BAKERSFIELD CITY SCHOOL DISTRICT
WILLIAM PENN ELEMENTARY SCHOOL MODERNIZATION
BAKERSFIELD, KERN COUNTY, CALIFORNIA

ADDENDUM NO. #03
NOTICE TO CONTRACTORS FIGURING THIS WORK

ADDENDUM #03

**PARTIAL MECHANICAL PLAN
BUILDING A1 CLASSROOM 102-107**

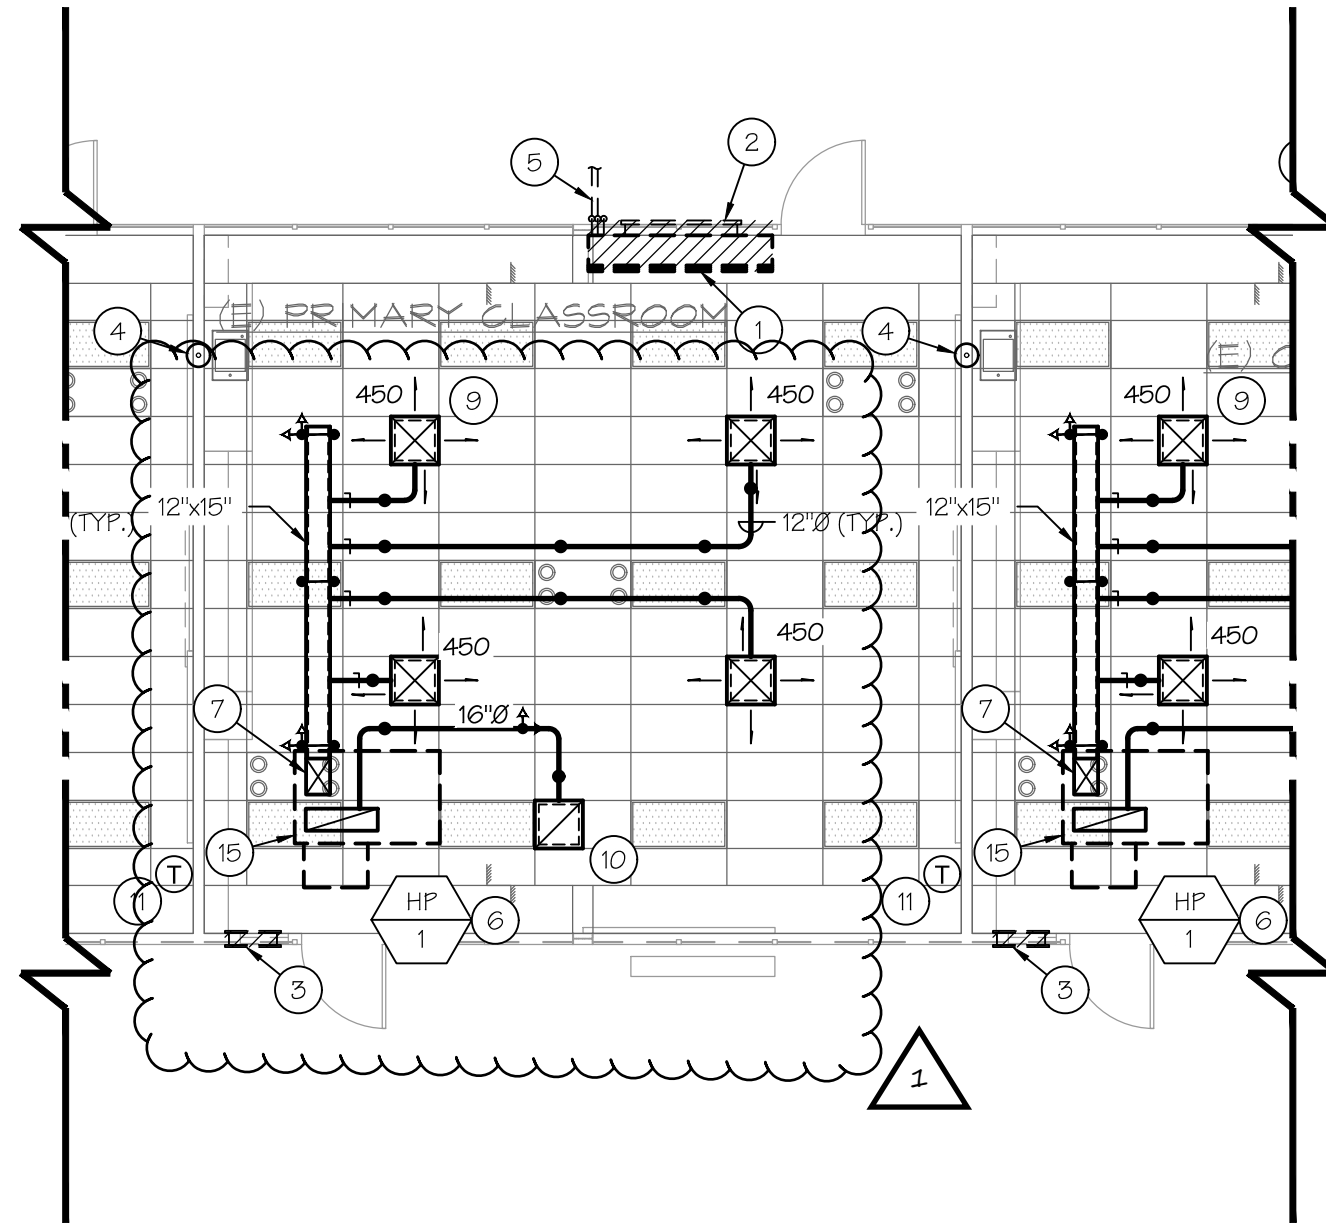
- 3-1) Refer to DSA Approved Drawings, Sheet No. M2.0 MECHANICAL FLOOR PLAN UNIT 'A1';
- a. REVISE: Ductwork for Room Nos. 102 through 107 as indicated per attached Drawing No. 01.

REVISE DUCT WORK

ITEM • 3-1)
REF. DSA APPROVED
DRAWING, SHEET M2.0

5 90° ANGLE T-BAR
SCALE: 3" = 1'-0"

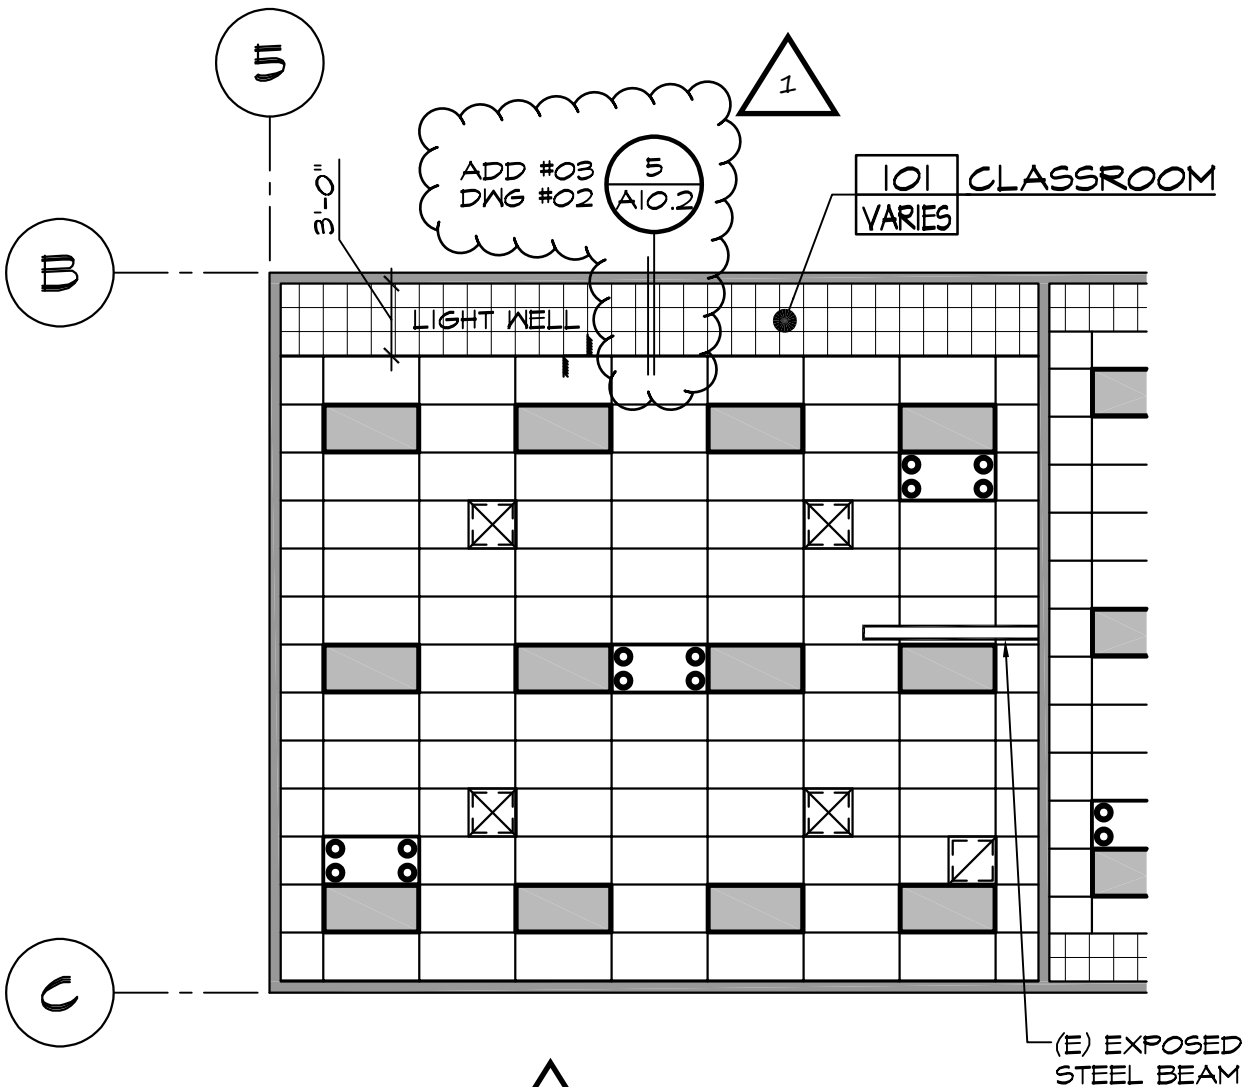
- b. CLARIFY: At Detail 4, BRACE shall be 3-1/2" x 1-5/8" LEG WITH A MAXIMUM LENGTH OF 10'-0".
 - c. ADD: Detail 5 as indicated per attached Drawing No. 02. See also Item #3-6 of this Addendum.

ADD DETAIL

ITEM • 3-5)c
REF. DSA APPROVED
DRAWING, SHEET A10.2

PARTIAL ROOF PLAN UNIT 'A1', 'A2A' & 'A2B'

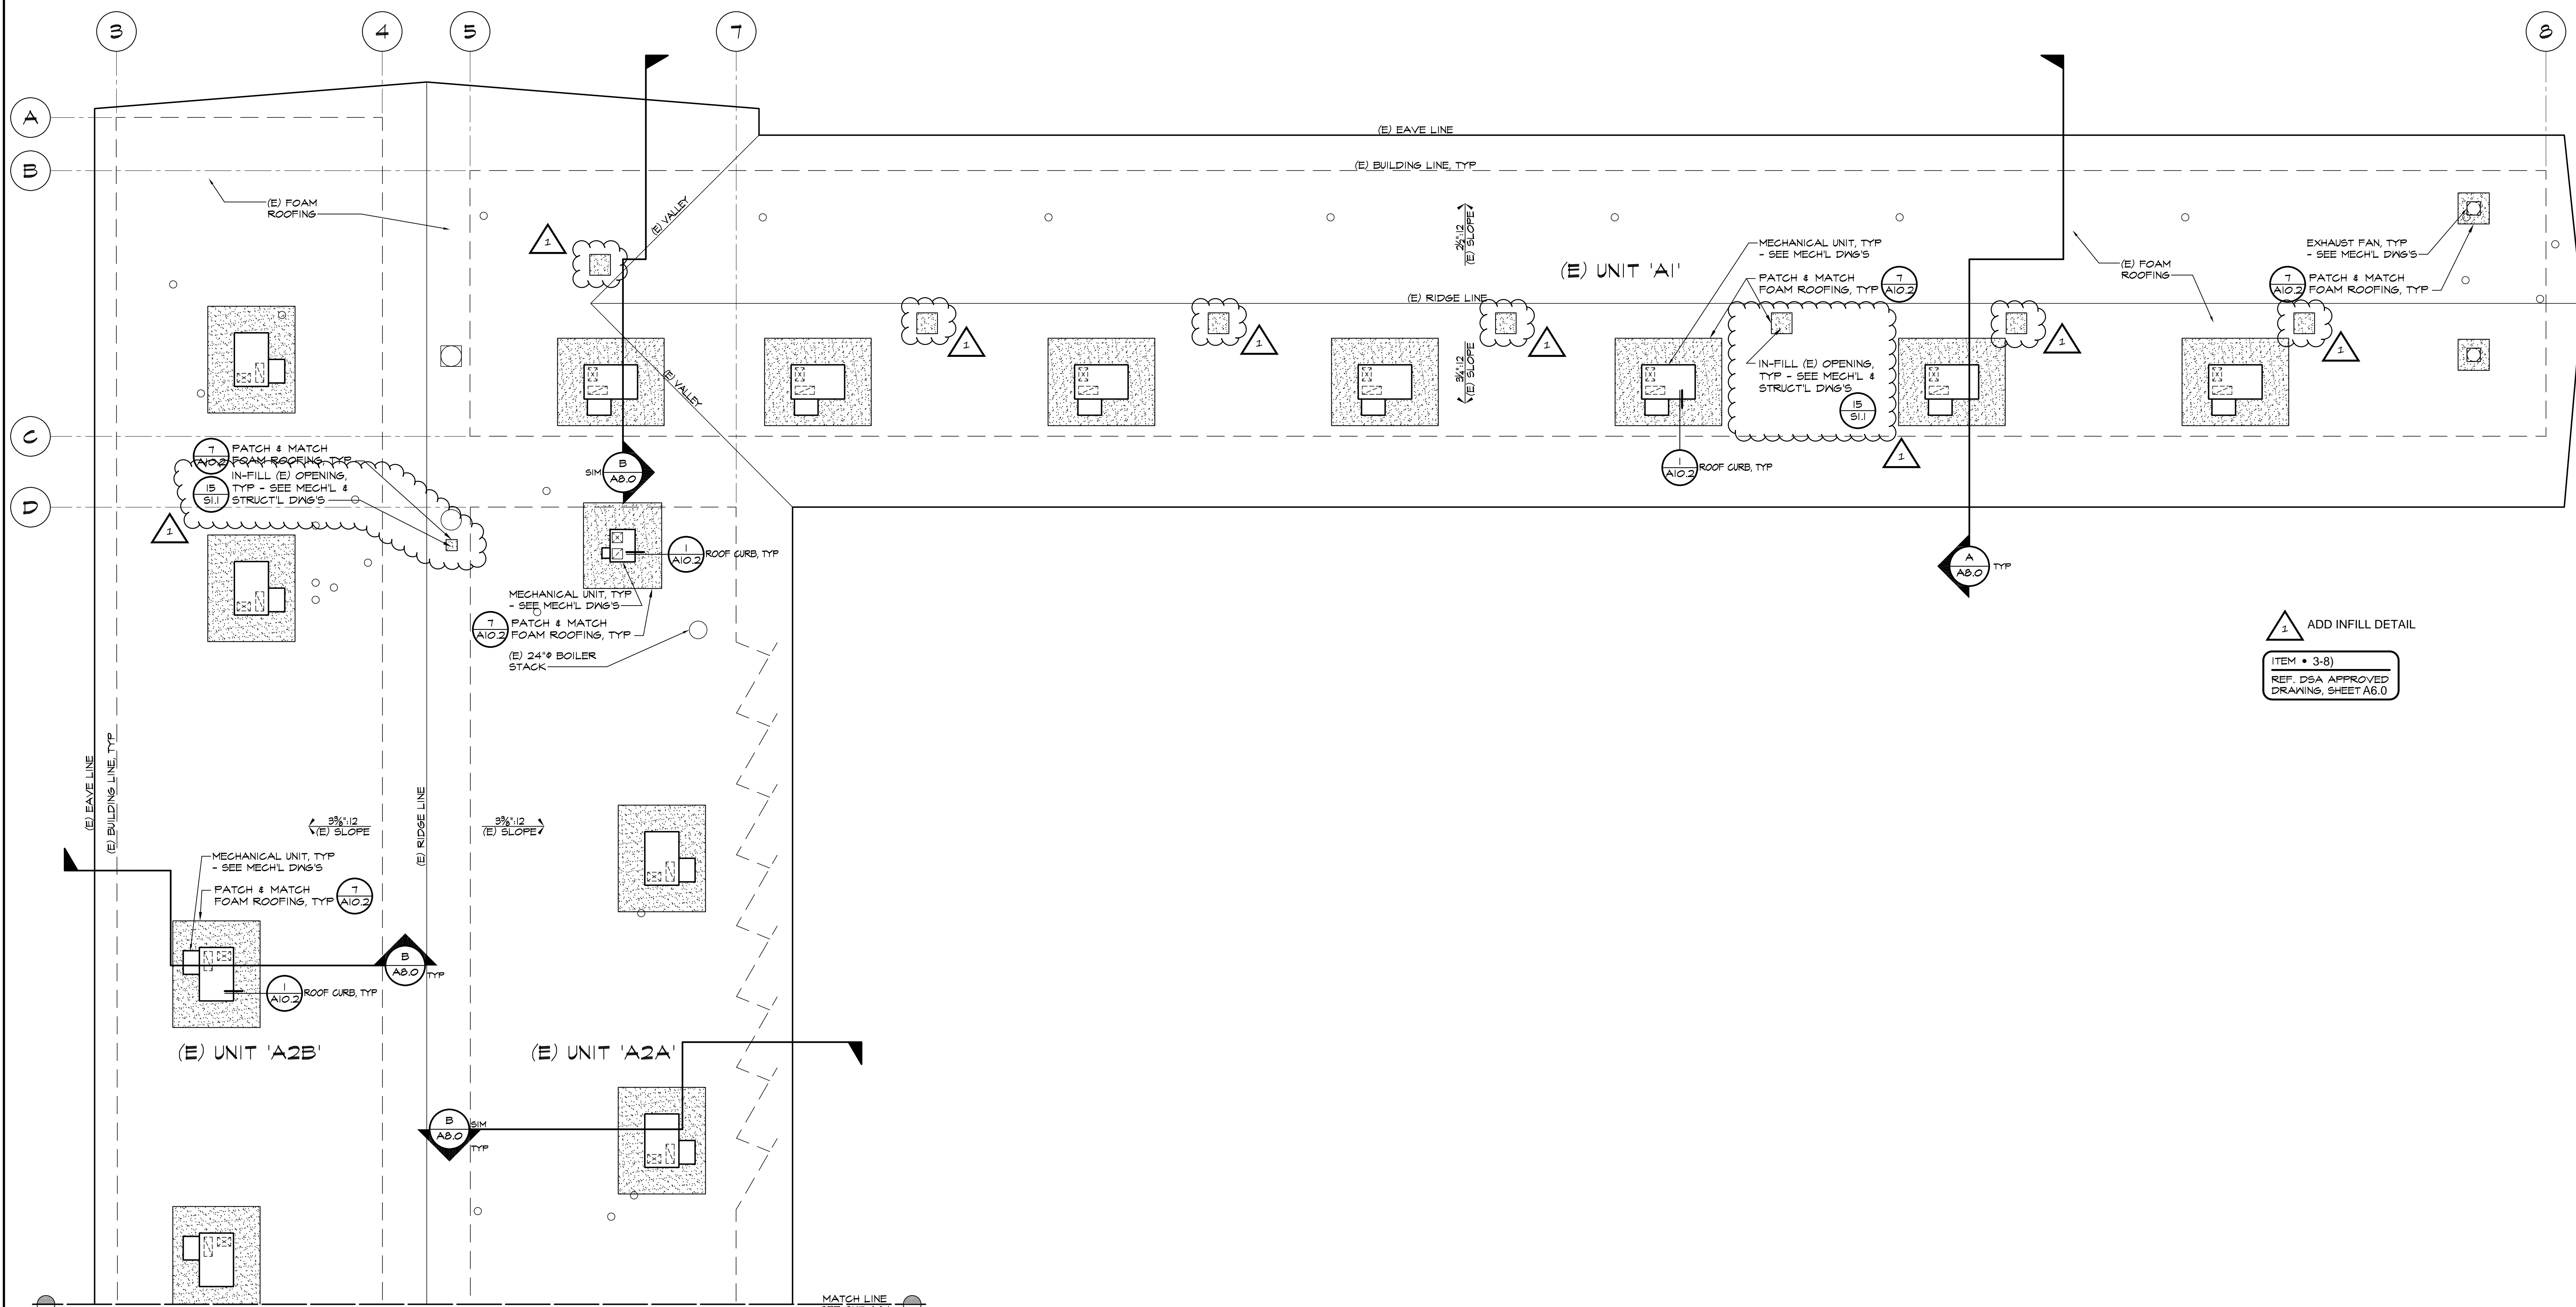
- 3-8) Refer to DSA Approved Drawings, Sheet No. A6.0 PARTIAL ROOF PLAN UNIT 'A1', 'A2A' and 'A2B';
- a. ADD: Detail Key 15/S1.1 to infill of (E) openings as indicated per attached Drawing No. 04.

▲ ADD INFILL DETAIL
 ITEM • 3-8
 REF. DSA APPROVED DRAWING, SHEET A6.0

SMALL OPENING IN NON-BEARING STUD WALL

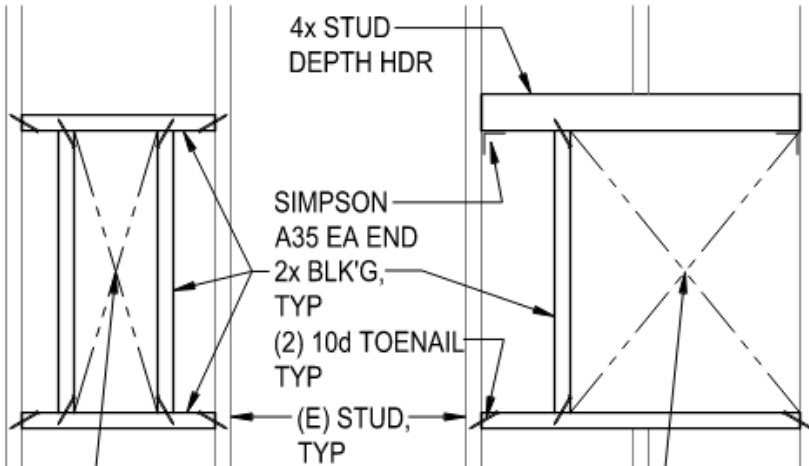
- 3-9) Refer to DSA Approved Drawings, Sheet No. S1.3 TYPICAL DETAILS;
- a. ADD: Detail #8 as indicated per attached Drawing No. 05. See also Item 3-10 of this Addendum.

- 3-10) Refer to DSA Approved Drawings, Sheet No. M2.1 MECHANICAL PLAN – UNIT 'A2A' and 'A2B',
ⓑ PARTIAL MECHANICAL FLOOR PLAN;
- a. ADD: Detail for opening at existing non-bearing studs where required for scheduled sizes of ductwork as indicated per attached Drawing No. 05.

1 ADD DETAIL

ITEM • 3-9) / 3-10)
REF. DSA APPROVED
DRAWING, SHEET S1.3 / M2.1
